# Access Compliance Report

## Public Rights-of-Way

### (Curb Ramps)

| Intersection ID: N/A | Main Street: GRIFFITH_ST | Cross Street: FAIRWOOD_AV | Location: S            |

| ADA ID: C5C4A83C94B4 | Ramp Type: Perp          | Initial Pass/Fail: Fail   | Overall Compliance: No |

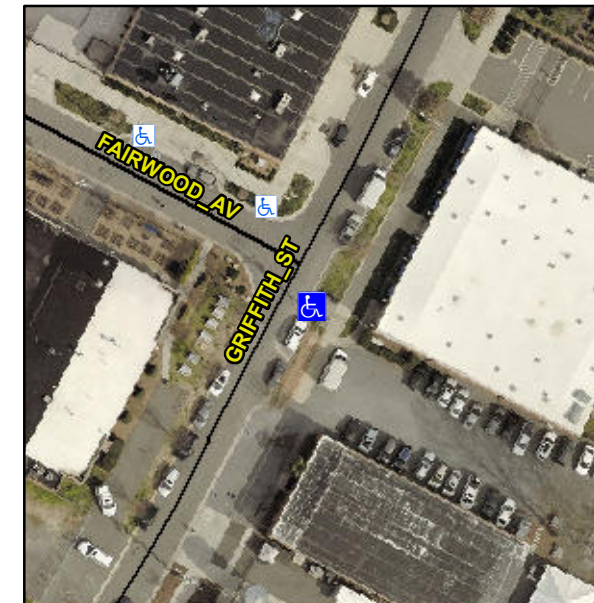
**Not Found, R304.2.2, R304.5.3**

| Compliance | Description           | Data  | Compliance | Description                 | Data |
|------------|-----------------------|-------|------------|-----------------------------|------|
| N/A        | Ramp Length (in)      | 80.0  | No         | Ramp Slope (%)              | 8.9  |
| Yes        | Ramp Width (in)       | 49.0  | No         | Ramp XSlope (%)             | 5.1  |

**Remove & Replace Entire Ramp.**
